SAN FRANCISCO PLANNING DEPARTMENT

Memo to the Planning Commission

Date: May 12, 2014
Case No.: 2013.0314D
Project Address: 1110 Ashbury Street
Permit Application: 2013.04.05.3911
Zoning: RH-2 (Residential House, Two-Family)
40-X Height and Bulk District
Block/Lot: 2629/021
Project Sponsor: Bill Pashelinsky
197 Hayes Street
San Francisco, CA 94117
Staff Contact: Jessica Look – (415) 575-6812
jessica.look@sfgov.org
Recommendation: **Do not take DR and approve the project as proposed.**

ALTERATIONS
 1110 ASHBURY STREET
 SAN FRANCISCO, CA.

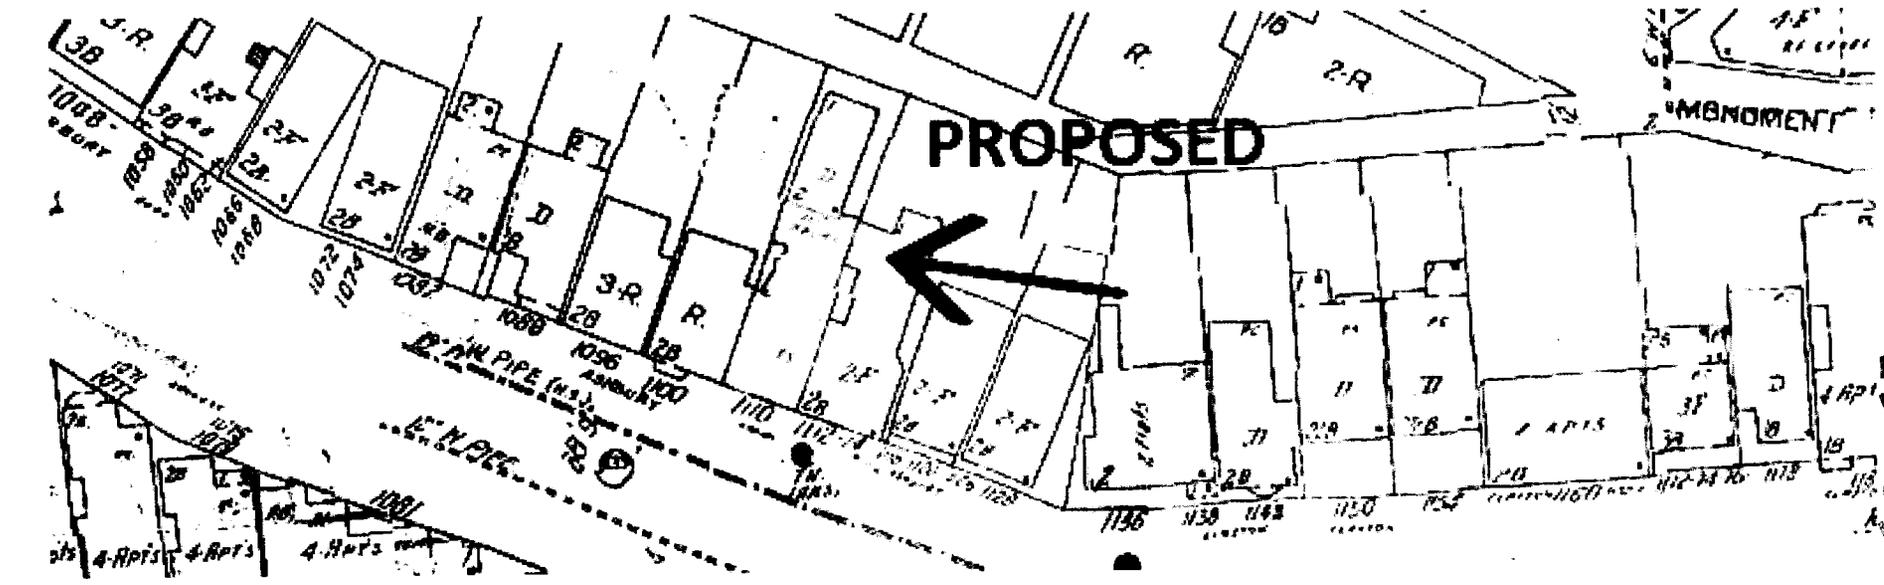
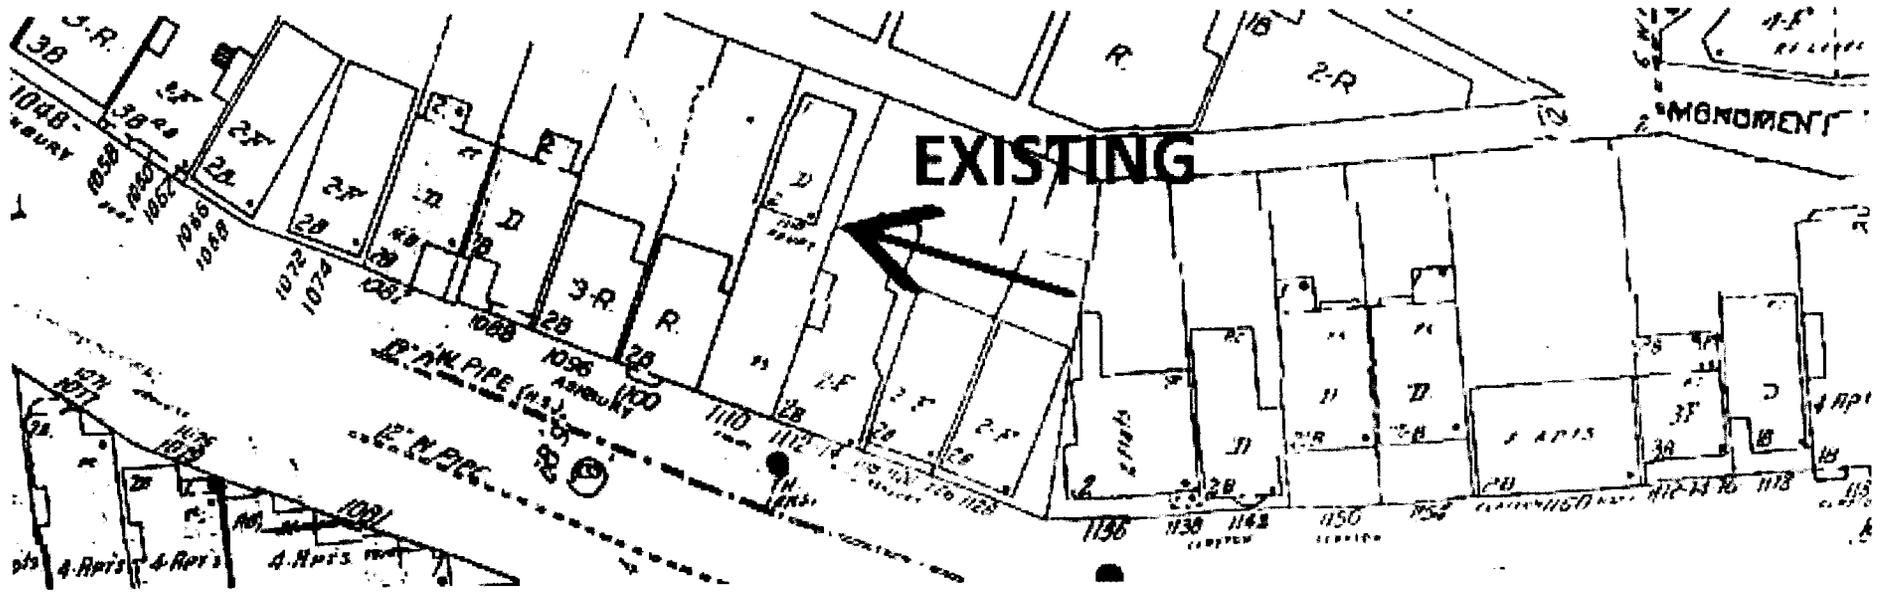
for the subject situation to correct this inequity and to fulfill the intent of the rear yard provisions. The minimum rear yard required for any residential development under the Planning Code is 25 percent of the subject lot's depth or 15 feet, whichever is greater."

The proposal also fails to meet the spirit of Design Guidelines having to do with Special Building Locations (page 21). While the Design Guidelines addressing existing cottages speak to adjacent development IT IS COMMON SENSE that the same principles would apply to a cottage proposed for expansion. THE REASON this circumstance was not specifically addressed in the Design Guidelines (developed in large part by Pedro Arce and Peter Albert) IS THAT IT WAS NEVER ENVISIONED A REAR COTTAGE WOULD ATTEMPT TO EXPAND FORWARD TO THE EXTENT LOT COVERAGE WOULD EXCEED 90%.

1110 Ashbury St.: Nearly 100% Lot Coverage Proposed

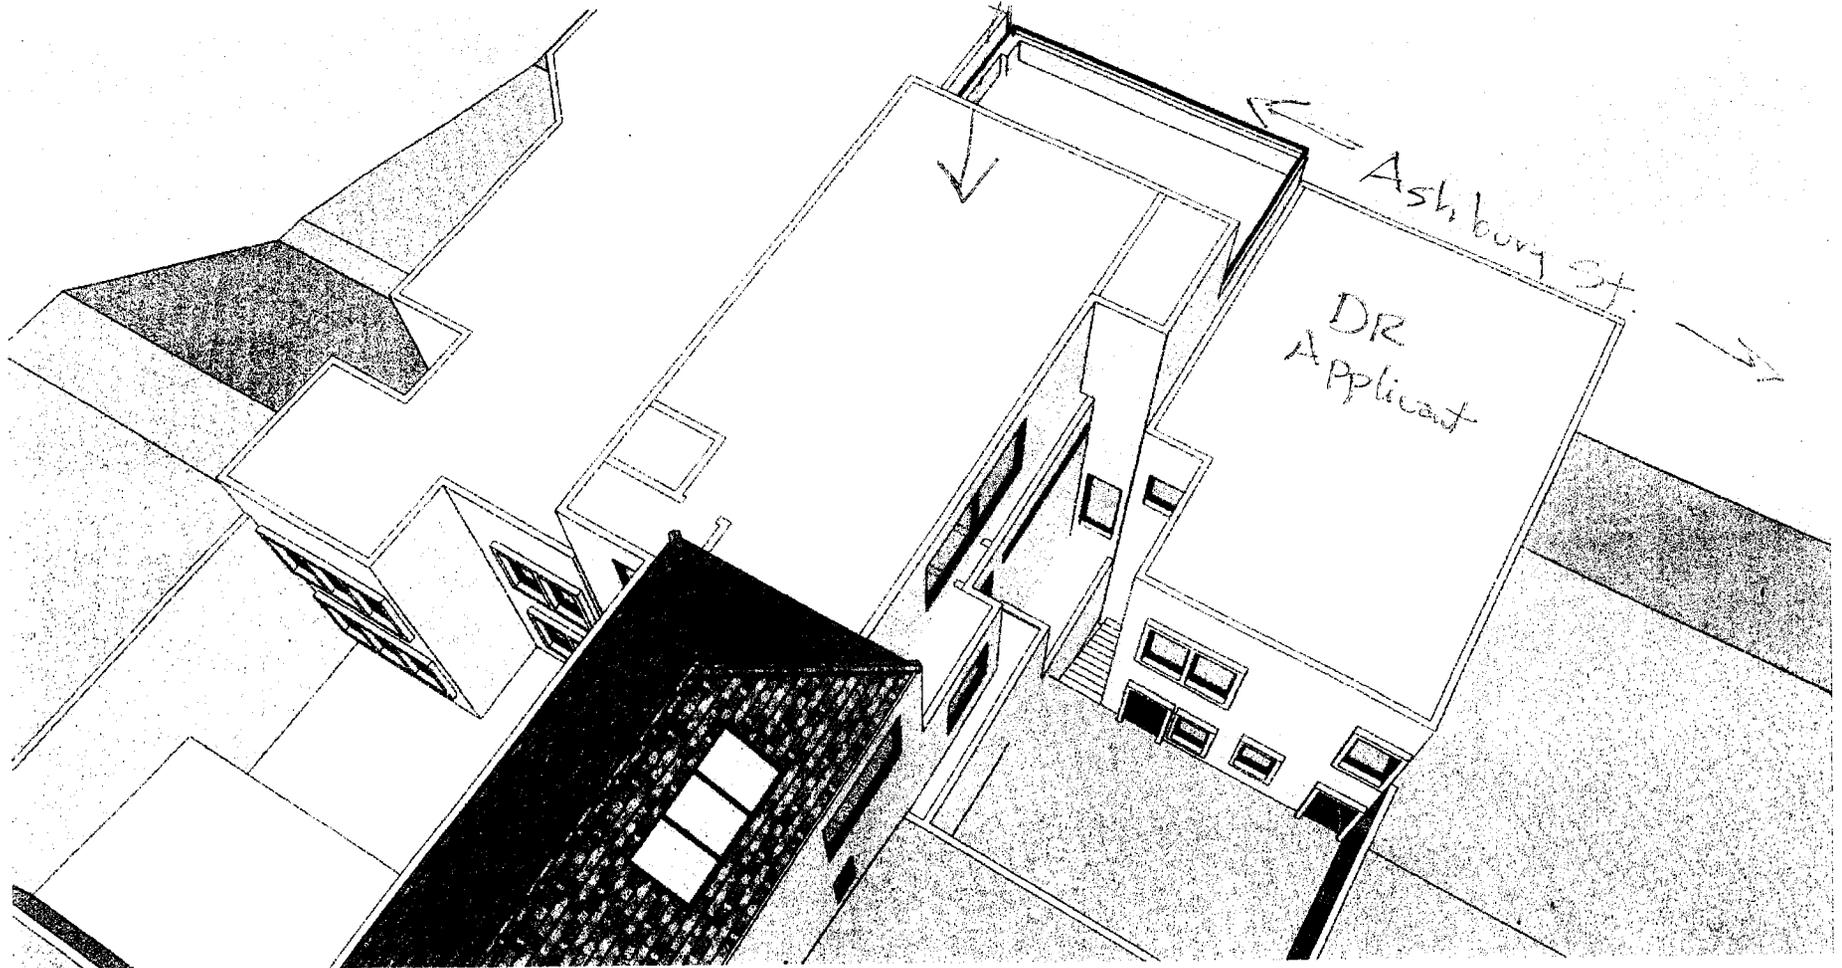
Existing + Proposed = nearly 100%
lot coverage!

Proposed June 21st at 9am

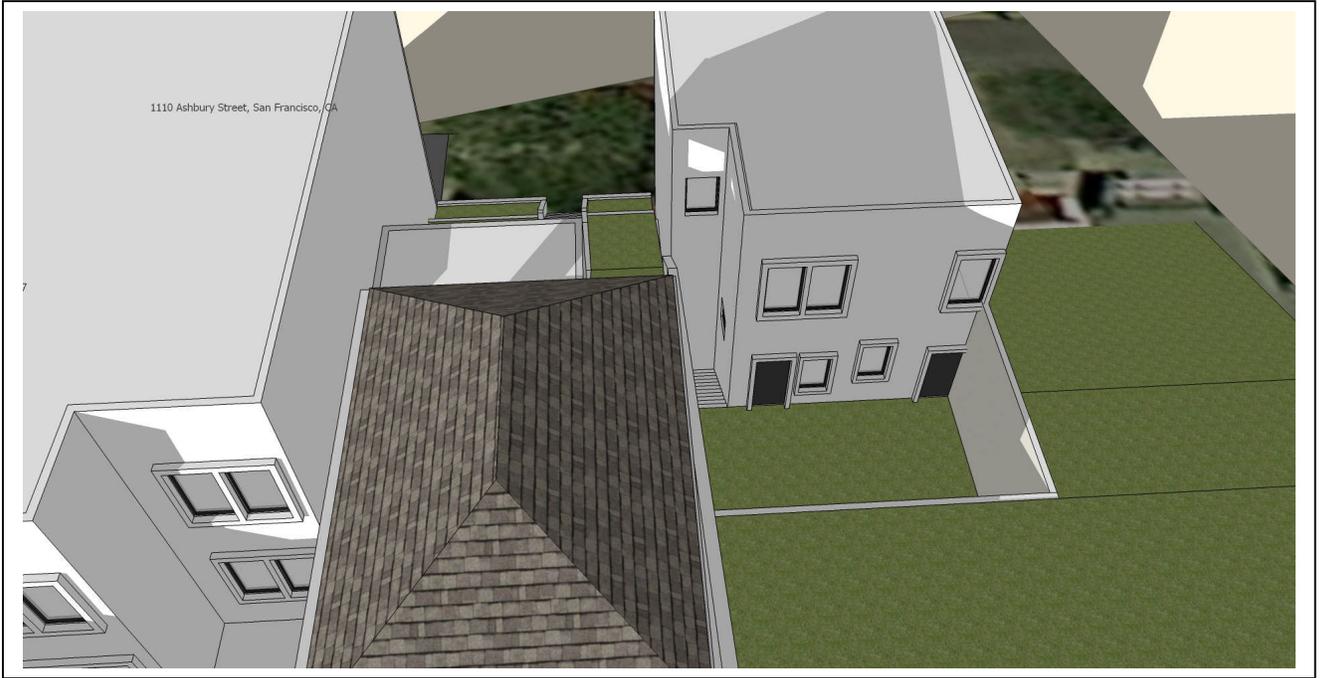
Conclusion: Proposed construction has no impact on adjacent lot on June 21st at 9am.

ATTACHMENT 5

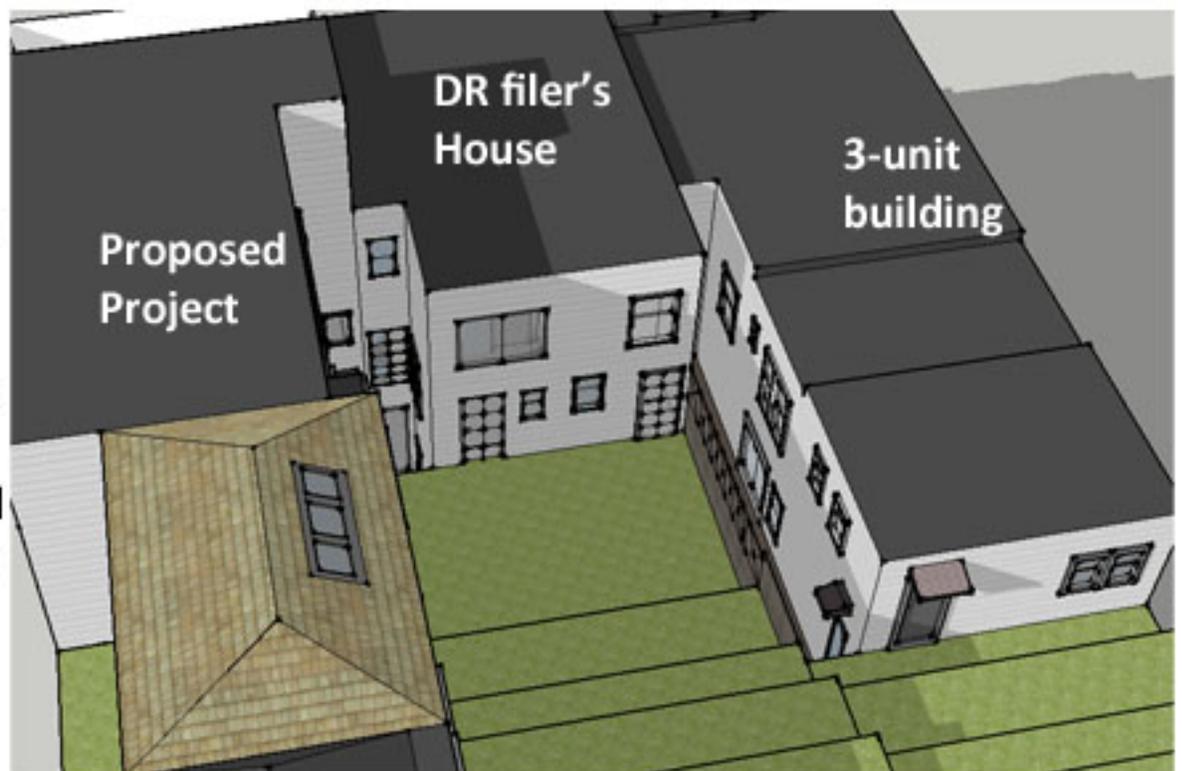
Existing circumstance: winter solstice noon (1 pm with daylight savings) when more than 50% of glazed area on back wall on the DR filer's house is in sun, as is all of the bedroom window in the lightwell.

Same day and time with project. Nearly all direct sun is blocked from DR filer's light well and rear building wall.
